**PLANNED UNIT DEVELOPMENT
& SUBDIVISION STAFF REPORT****Date: December 6, 2007**

DEVELOPMENT NAME Lakeside Commercial Park Subdivision, Joy Springs Addition

CONTEMPLATED USE Planned Unit Development Approval to allow shared access between two building sites, and Subdivision Approval to create 5 lots.

SITE PLAN

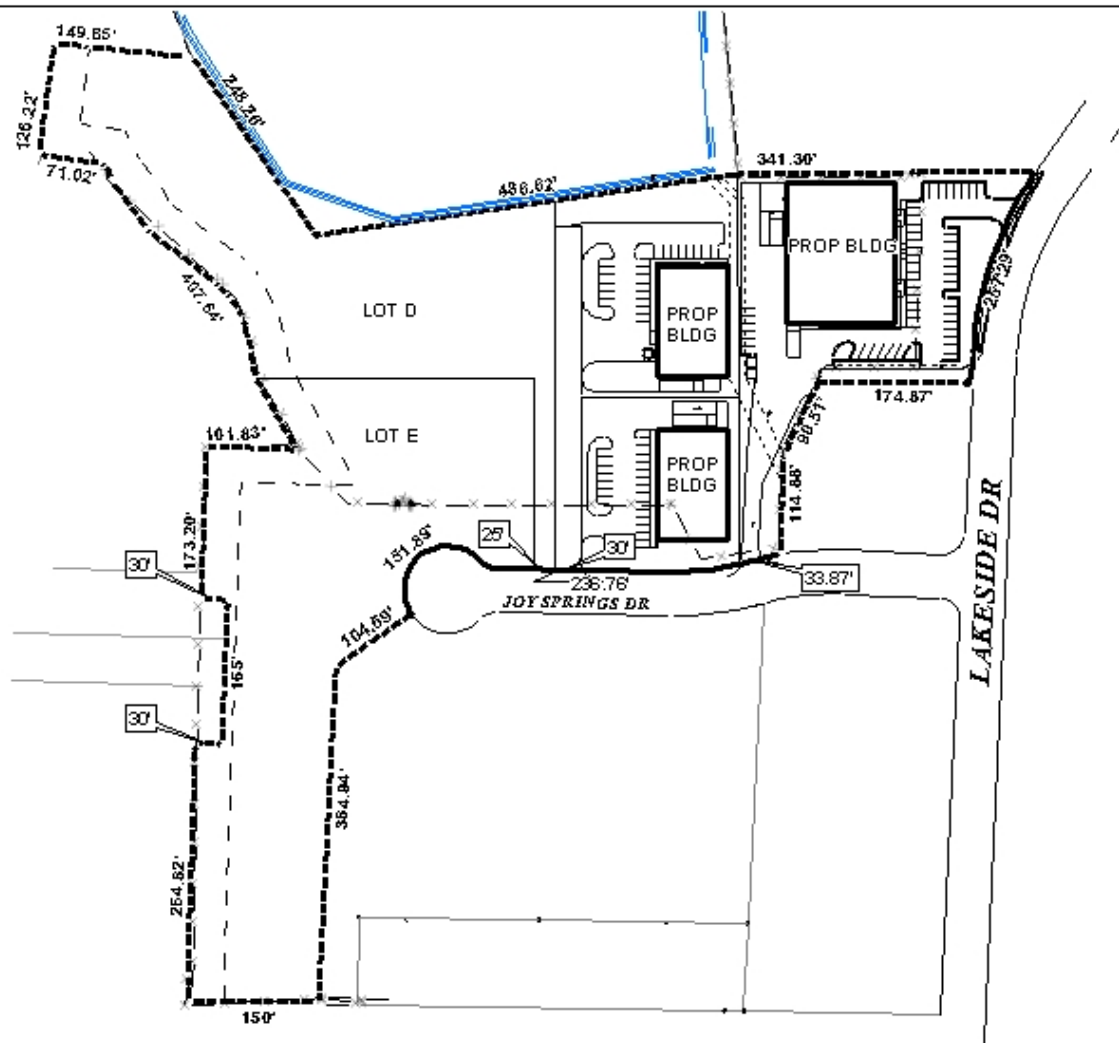
The purpose of the subdivision is to resubdivide two existing lots of record into five lots, creating four lots from one, and providing a second road frontage for the other. Two of the new lots are flag shaped, with the “pole” or “handle” adjacent to one another. This type of configuration generally indicates that potentially a new street, whether public or private may be more appropriate.

Another issue relating to the flag configuration is that of access – which also relates to the PUD. The PUD is to allow a shared access for lots B & C. This shared access utilizes the “pole” or “handle” for Lot C, and is immediately adjacent to the “pole” or “handle” for Lot D – which is presumably where it’s access will be obtained.

The narrative for the applications states that the development is to be an office-warehouse complex, but provides no information with regard to percentages of office (or retail) and warehouse. Therefore, parking calculations cannot be accurately performed.

No on-site storm water detention facilities are depicted on the site plan, however such facilities may be required due to the extent of the proposed new development. The site plan should be revised to depict any required on-site storm water detention facilities.

There is no indication on the site plan as to the proposed location of any dumpster or other waste storage facility. The location of the storage area for the dumpster must be indicated on the site plan, and the location and required screening must comply with Section 64-4.D.9. of the Zoning Ordinance, as well as with all other applicable regulations.

- 1) revision of the plat to eliminate the flag shaped lots and provide a street/cul de sac;
- 2) on-site storm water detention facilities;
- 3) provision of sidewalks or submission of a sidewalk waiver application

- 1) revision of the plat to eliminate the flag shaped lots and provide a street/cul de sac;
- 2) on-site storm water detention facilities;
- 3) provision of sidewalks or submission of a sidewalk waiver application
- 4) location of the storage area for the dumpster must be indicated on the site plan
- 5) provision of sidewalks or submission of a sidewalk waiver application
